Staff Report & Recommendation

Design Review Board

SUBJECT: DRB17-0207
1698 Alton Road and 1681-1683 West Avenue

The applicant has submitted plans entitled "17th and West Avenue", as prepared by **Stantec**, dated January 5, 2018.

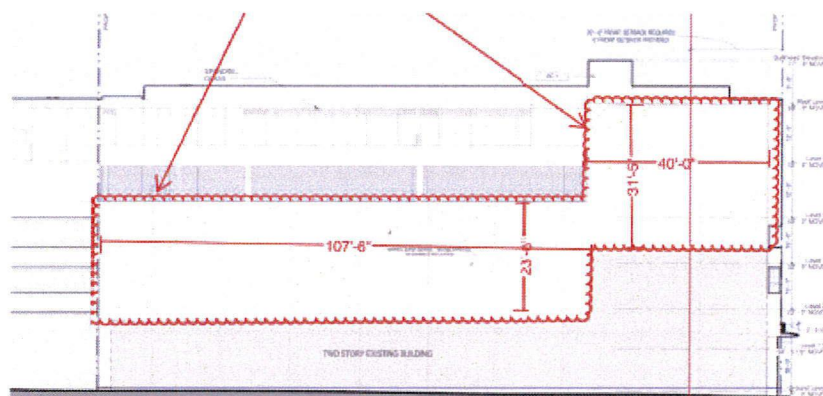
The applicant has shown a signage program for the ground floor tenants that will have the ability to differ in size, font style and color. A proper uniform signage plan should be designed to be consistent in materials, design type, method of illumination and sign location. When a building has multiple uses or storefronts, signs should be of a consistent size, type and location. This is not to suggest that creativity in types of signs be impeded, only that a rational relationship between the various entities within a building be established.

Specifically, a regimented uniform sign program, consisting of the exact same style, color and type of sign, is strongly discouraged. All signage should embrace the following: 1. A combination of some form of individual or channel letter, such as front lit, back lit or open face; 2. Variations in letter style, size, color and material; 3. All signage should be located in a similar vicinity, unique to each storefront; 4. Clear and precise detailing regarding method of connection and installation to building façade or architectural element; and, 4. Details of methods of illumination, conduits and wiring. Staff would recommend that all the storefront signs be designed as individual reverse channel letters with a brushed aluminum finish that can each be

backlit with a color so desired by each future tenant. Staff would recommend the maximum height of any individual letter not exceed 18" in height and that all proposed letters be composed of a brushed aluminum finish. Staff is confident the project architect can successfully address the concerns raised herein, as well as the additional concerns enumerated in the attached draft order.
